PSEG Nuclear LLC is authorized to operate the facility at a steady state reactor core power level not in excess of 3459 megawatts (one hundred percent of rated core power).

The Technical Specifications contained in Appendices A and B, as revised through Amendment No. 243 are hereby incorporated in the license. The licensee shall operate the facility in accordance with the Technical Specifications.

FIGURE 2.1-1  
 REACTOR CORE SAFETY LIMIT - FOUR LOOPS IN OPERATION

Figure 3.4-2 Salem Unit 1 Reactor Coolant System Heatup Limitations  
 Applicable for Heatup Rates up to 100°F/HR for the Service  
 Period up to 32 EFPY (with uncertainties for instrumentation  
 errors).

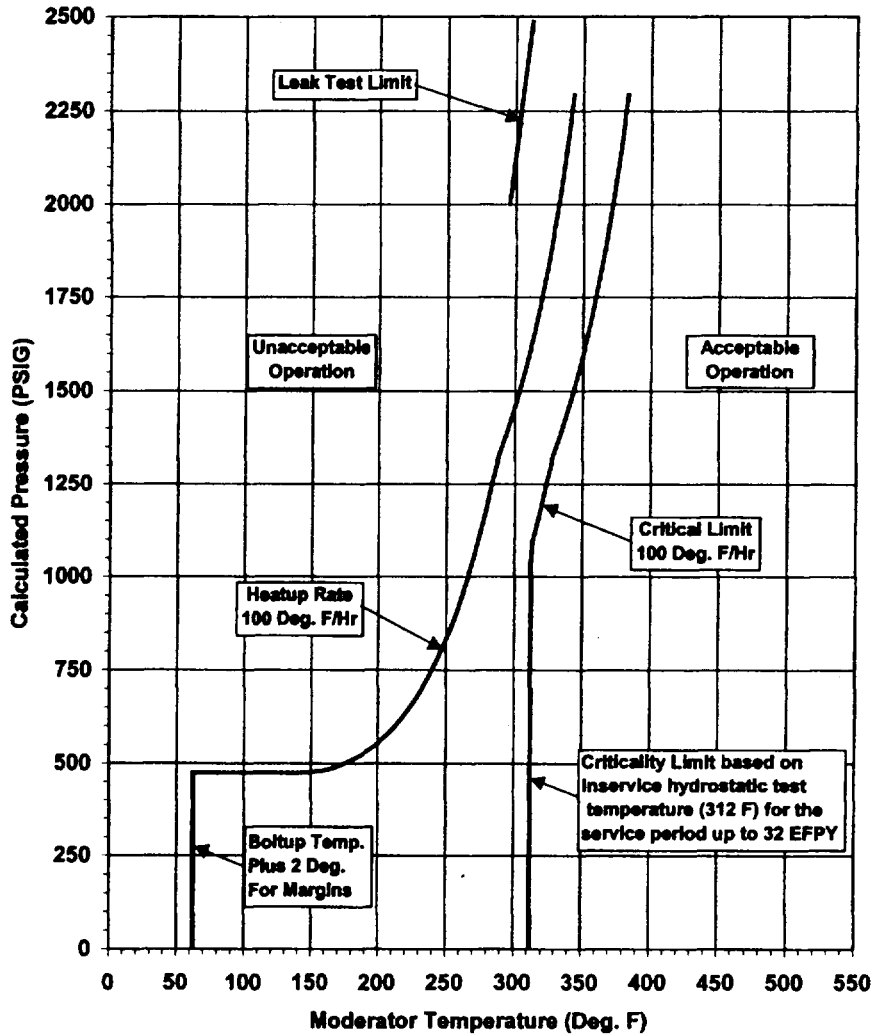
- 1) The reactor coolant temperature and pressure and system heatup and cooldown rate (with the exception of the pressurizer) shall be limited in accordance with Figures 3.4-2 and 3.4-3 for the service period specified thereon.

- a) Allowable combinations of pressure and temperature for specific temperature change rates are below and to the right of the limit lines shown. Limit lines for cooldown rates between those presented may be obtained by interpolation.

- b) Figures 3.4-2 and 3.4-3 define limits to assure prevention of nonductile failure only. For normal operation, other inherent plant characteristics, e.g., pump heat addition and pressurizer heater capacity, may limit the heatup and cooldown rates that can be achieved over certain pressure-temperature ranges.

The heatup and cooldown limit curves of Figures 3.4-2 and 3.4-3 include predicted adjustments for this shift in  $RT_{NDT}$  at the end of 32 EFPY.

Figure 3.4-2

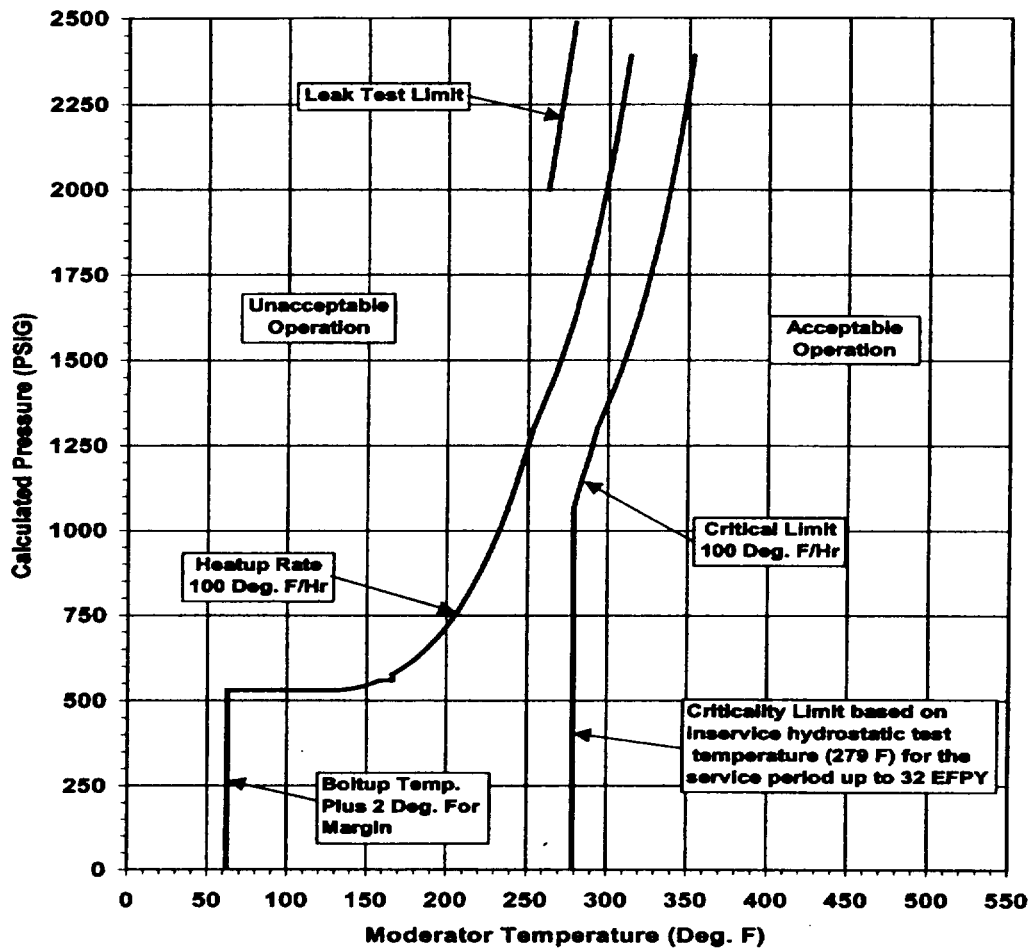
- 1) The reactor coolant temperature and pressure and system heatup and cooldown rate (with the exception of the pressurizer) shall be limited in accordance with Figures 3.4-2 and 3.4-3 for the service period specified thereon.

- a) Allowable combinations of pressure and temperature for specific temperature change rates are below and to the right of the limit lines shown. Limit lines for cooldown rates between those presented may be obtained by interpolation.

- b) Figures 3.4-2 and 3.4-3 define limits to assure prevention of nonductile failure only. For normal operation, other inherent plant characteristics, e.g., pump heat addition and pressurizer heater capacity, may limit the heatup and cooldown rates that can be achieved over certain pressure-temperature ranges.

The heatup and cooldown limit curves of Figures 3.4-2 and 3.4-3 include predicted adjustments for this shift in  $RT_{NDT}$  at the end of 32 EFPY.
